FINAL ENVIRONMENTAL IMPACT REPORT

10131 Constellation Boulevard

ENV-2004-6269-EIR

April 2006

Figure 57 (Revised)
Revised Locations of Parks
and Recreational Facilities

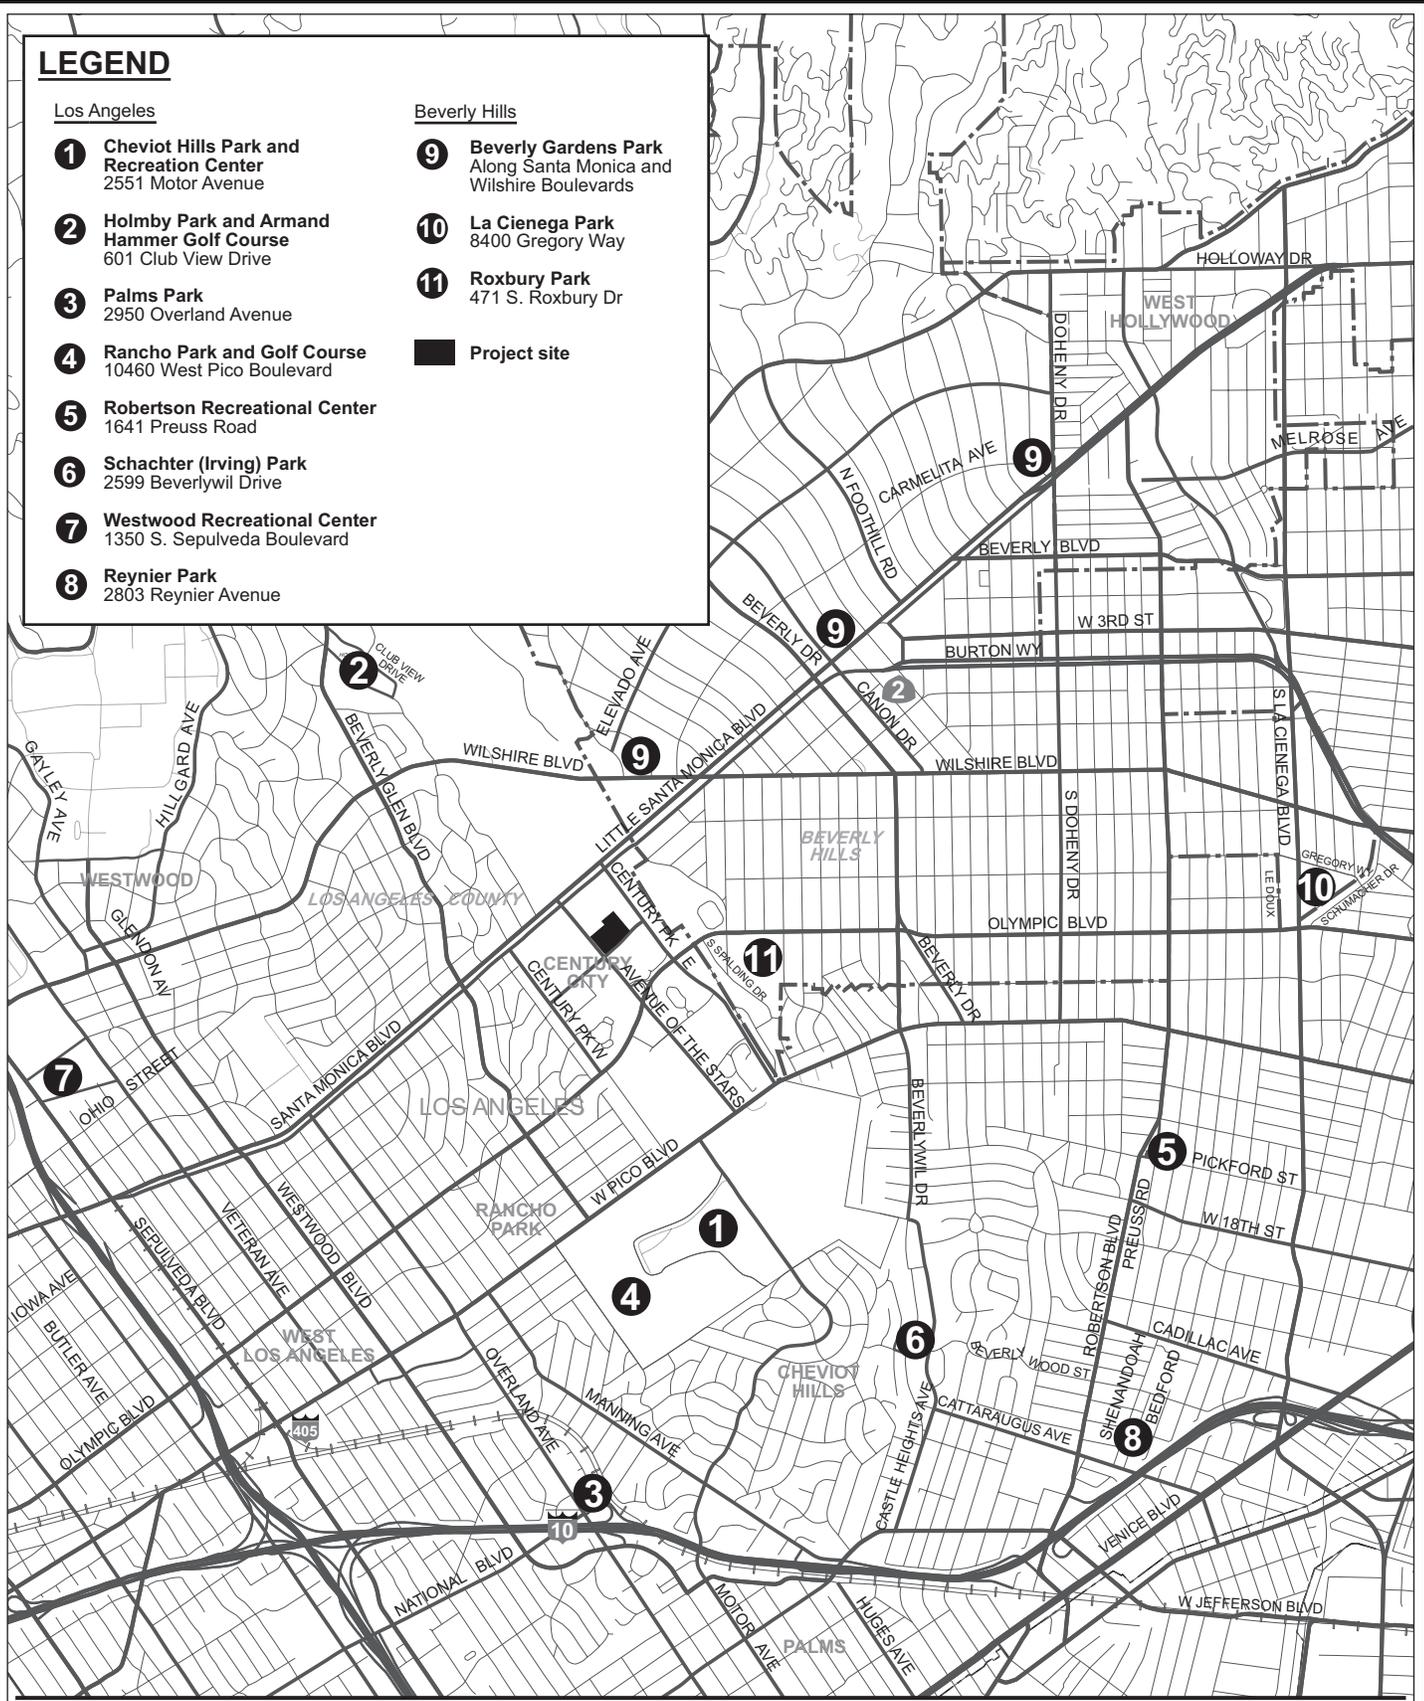
Figure 57, page 405: #8 should be Roxbury Park. # 11 near Cattaraugus Ave. is Reynier Park, and the #11's along Santa Monica Blvd. should be #9.

a. Volume I, Section IV.H.4, Parks and Recreation, page 405, replace Figure 57 with that shown on page 92.

Figure 57 on page 405 of the Draft EIR has been revised. Please refer to Correction and Addition No. IV.H.4.a as presented in Section III, Corrections and Additions, of this Final EIR. This correction does not alter the conclusions set forth in the Draft EIR.
